MEMORANDUM

From:	Tina Cuss Ecology Officer		
Service	WBC Ecology	App No:	251233
Address:	Warren Crest Farm, Wick Hill Lane, Finchampstead, Wokingham, RG40 3PY.		
Proposal:	Full application for the proposed erection of 3no. dwellings following demolition of existing dwelling, outbuilding and agricultural barns.		
Type of Development:	Minor Dwellings (1-9)		
Site Visit Made:	No

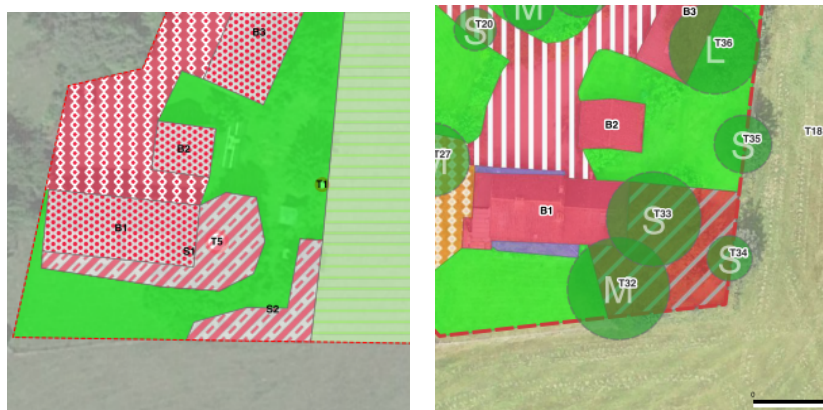
Birds are recorded nesting in B1, B2, B3 and B4. More information is needed to ensure that Habitat or 1SP Schwegler Sparrow terraces recommended are adequate to compensate for the loss of wild bird nesting habitat. Opportunities to provide compensation and enhancement for swifts or barn owl in the proposed eastern dwellings have not been considered in the EclA.

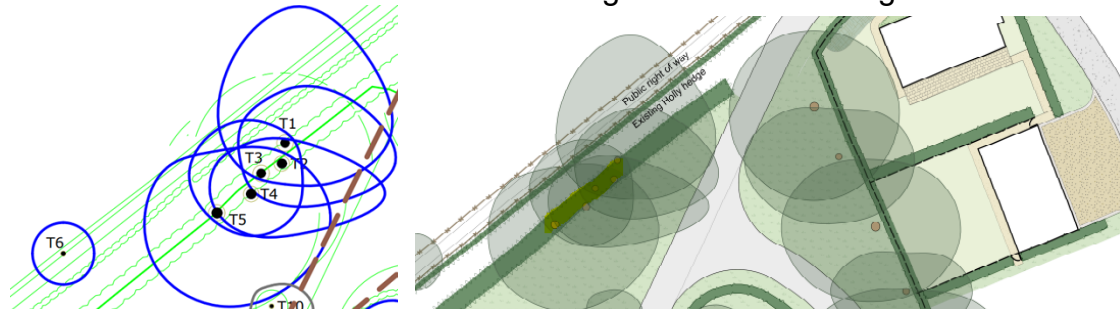
information submitted in the EclA and LVIA I consider that the site supports traditional orchard, modified grassland, introduced scrub, vegetated garden, native and ornamental hedgerow, individual trees and ecologically valuable lines of trees and a dry ditch.

Tree T28 has been omitted from the Individual Trees Condition Sheet in appendix 6. A revised report should address that the Ecologist's assessment of tree size and species is inconsistent with the AIA. The Arboriculturist identified T28 as a cherry and assesses the diameter at breast height as 27cm. The tree should therefore be recorded as a small tree in moderate habitat condition. 4 large and one medium Oak trees T1 to T5 are on-site and have also been missed from the condition assessment and the metric. These trees need either to be assessed as an Ecologically valuable line of trees or the northern section of hedge recorded as hedgerow with trees.
